Bayside Planning Panel

Item No	6.7
Application Type	Development Application – Mixed Use Development (Commercial and Residential Building)
Application Number	DA-16/237
Lodgement Date	16 December 2016
Property	23 Swinbourne Street, Botany Lot 1 in DP 85872
Owner	Bartul and Maria Barbic
Applicant	Lurline Constructions P/L C/- Technik Haus P/L
Proposal	Integrated development for the demolition of the existing structures on site and construction of a three storey shop top housing development and basement parking.
No. of Submissions	Three objections (First round) Nil (Second round)
Cost of Development	\$3,000,000.00
Report by	Angela Lazaridis, Senior Development Assessment Officer

Supplementary Planning Assessment Report

Figure 1. Amended plans demonstrating the balconies within the site

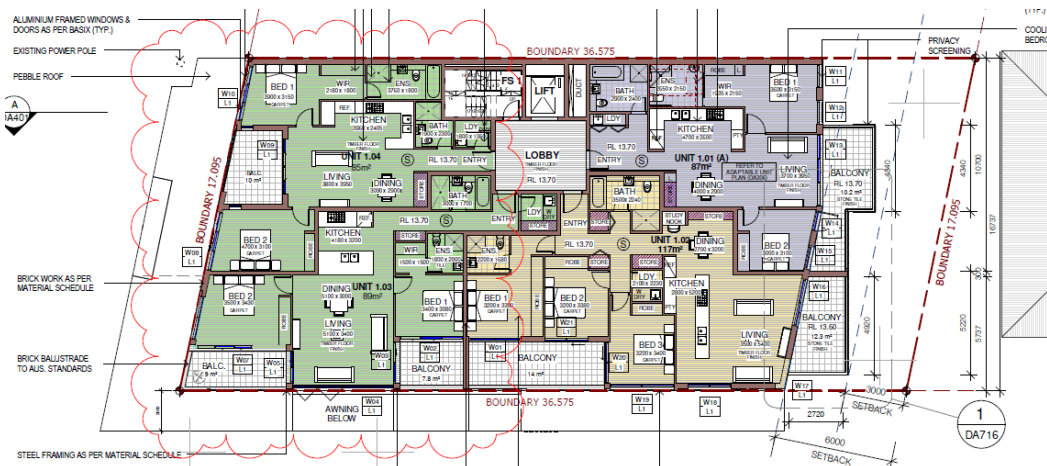
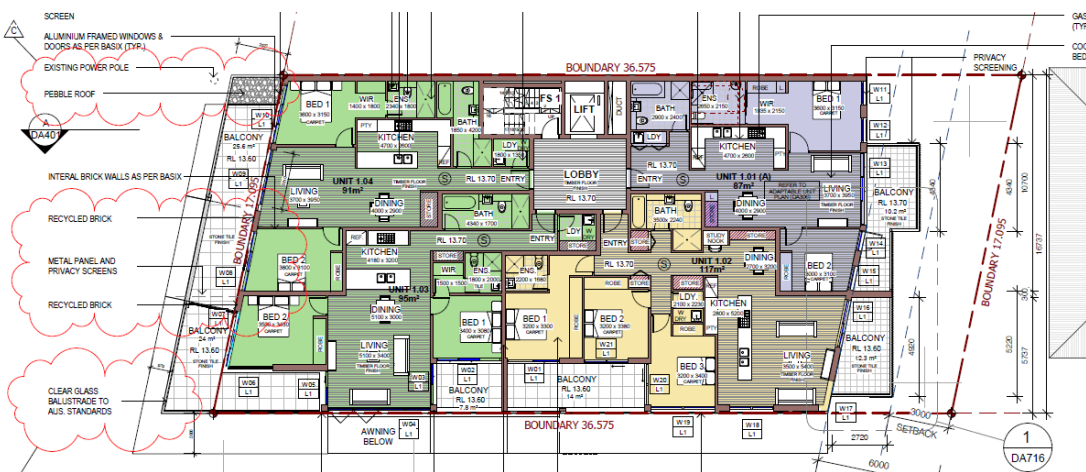
The Panel raised issue with the balconies that form part of the private open space area of U1.03 and U1.04 which were originally located over the awning along the southern elevation of the site. The balconies were originally over Council land and owners consent had not been given by Council. Following the meeting, Council agreed not to provide owners consent for the construction of the two balconies and requested that the applicant redesign the first floor along the southern elevation to encompass the private open space to these two units within its own boundaries. The applicant provided amended plans providing the balconies within the site. U1.04 has reduced the size of the unit from 91sqm to 81sqm to accommodate a 10sqm balcony whereas U1.03 has two balconies which have an area of 9sqm and 7.8sqm respectively (Figure 1). It is noted that this now forms a non-compliance with Control 5.2.2.5 of the BBDCP whereby the development is required to be in accordance with the desired future character for the Swinbourne Street Neighbourhood Centre. It is noted that the change in the policy direction will now provide an inconsistent streetscape given existing approvals in the neighbourhood Centre as shown in Figure 3. As the entire building is now located within the boundaries of the site, this issue has been resolved.

On 27 October 2017, the applicant provided Council with amended plans demonstrating the balconies of Units 1.03 and 1.04, which were located on top of the awning over Councils footpath at its southern elevation, have now been designed within the boundaries of the site. This results in a decrease in the size of Unit 1.04 to accommodate a larger balcony. Secondly, the plans have been amended to demonstrate that the balconies along the eastern elevation of Level 2 are now setback away from the boundary. Originally, the balconies had extended to the eastern boundary whereas now they have been setback 1.8 metres. Finally, in regards to façade resolution and articulation of the ground floor corner retail tenancies, the applicant has altered the materials within the proposal. A masonry corner has been introduced to create a more prominent element as opposed to originally comprising of floor to ceiling glass panels. The use of both masonry and glass continues to allow for appropriate surveillance as well as frames the corner making it distinguishable.

Figure 3. Swinbourne Street Desired Future Character

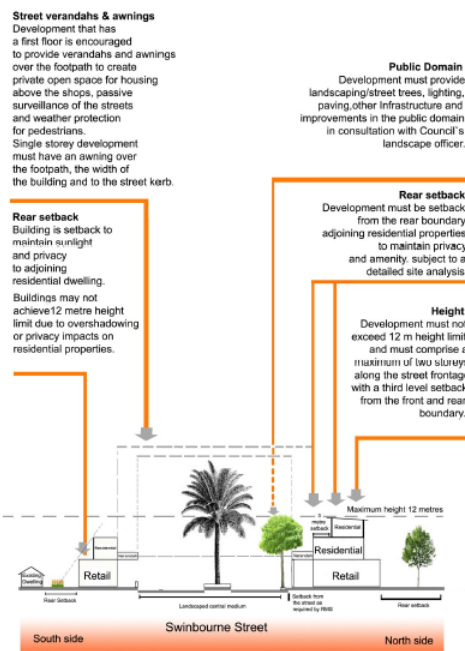
The applicant had originally proposed floor to ceiling glass on the south-eastern corner of the site within the retail tenancies (Figure 4). The Panel had issue with the material proposed as it suppressed the corner and suggested alternate material choice which would frame the corner and make it more prominent from the surrounding sites. Amended plans were submitted demonstrating a change in the materials and façade treatment along the ground, first and second floors on the southern and eastern elevations. The use of facebrick in particular along the south eastern corner provides a visually interesting corner while continuing to maintain casual surveillance from the retail areas. The first floor balconies also incorporate a mix of facebrick and rendered brick which is demonstrated in Figure 5 below.

Figure 11: Reproduction of Figure 20 from Part 5 of BBDCP2013

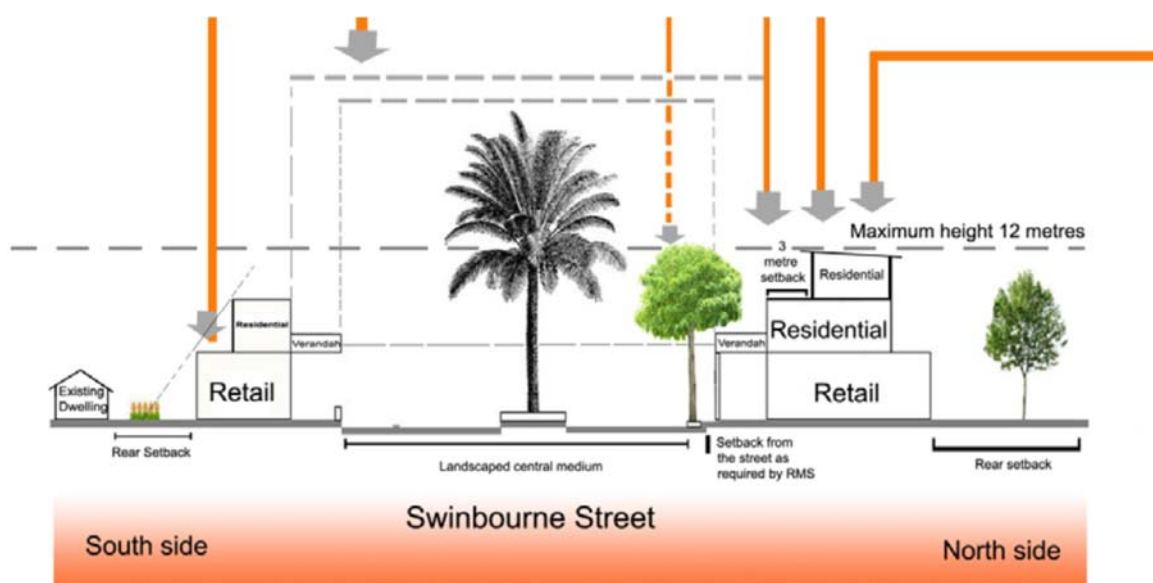
C4 The design of development must be generally consistent with the Desired Future Character of the centre identified in Figure 20	The proposal complies and has been designed to reflect Figure 20 within the Desired Future Character section of the DCP.	Yes
C5 A maximum height of 12 metres applies under BBLEP 2013. Notwithstanding the 12 metre height limit, a maximum height of two stories applies along the street frontage with a third level permitted which is setback from the street frontages and the rear. The setback from the rear is to be determined following a detailed site analysis at development application stage and must satisfy Council that the amenity of neighbouring residential properties are protected in terms of sunlight and natural daylight access, privacy and visual amenity. Applicants must therefore demonstrate at development application stage that impacts on the residential area are minimised.	The proposal exceeds the height of the development with the lift overrun and the pergola protruding by 1.55m above the height requirement. This has been discussed in Note 3 above. Notwithstanding, the second floor has been setback away from the side boundaries. A visual privacy analysis has been carried out by the applicant from the balconies on the second and first floor to the north of the site to demonstrate whether any negative overlooking onto the neighbouring residential properties will occur. From the plan, the development is acceptable.	No – Refer to Note 3

Figure 1: Section Plan demonstrating height non-compliance (highlighted in yellow)

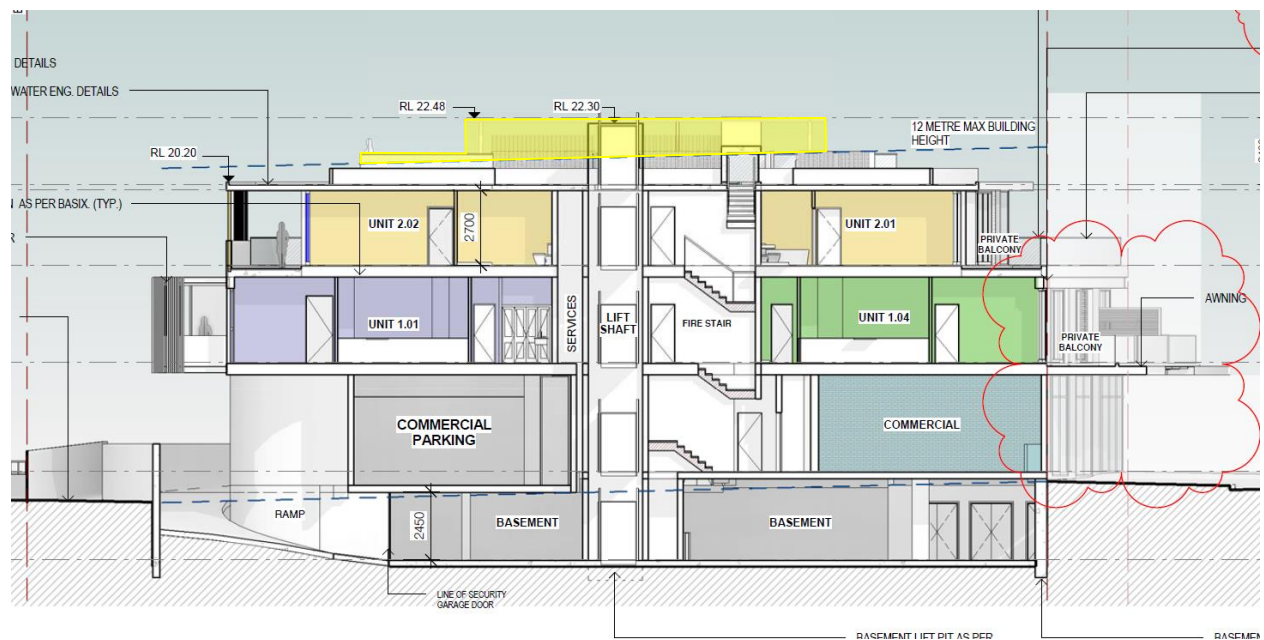
Figure 1 below provides a Section Plan indicating that the building has been designed to comply with the maximum permitted height, however, results in non-compliances that predominantly relate to the lift overrun and pergola that extend to a maximum height of 13.55m (equivalent to a 12.9% variation).

As indicated, the height non-compliance is limited to the lift overrun and pergola. The proposed development is however considered to be generally consistent with the scale of development expected at the site.
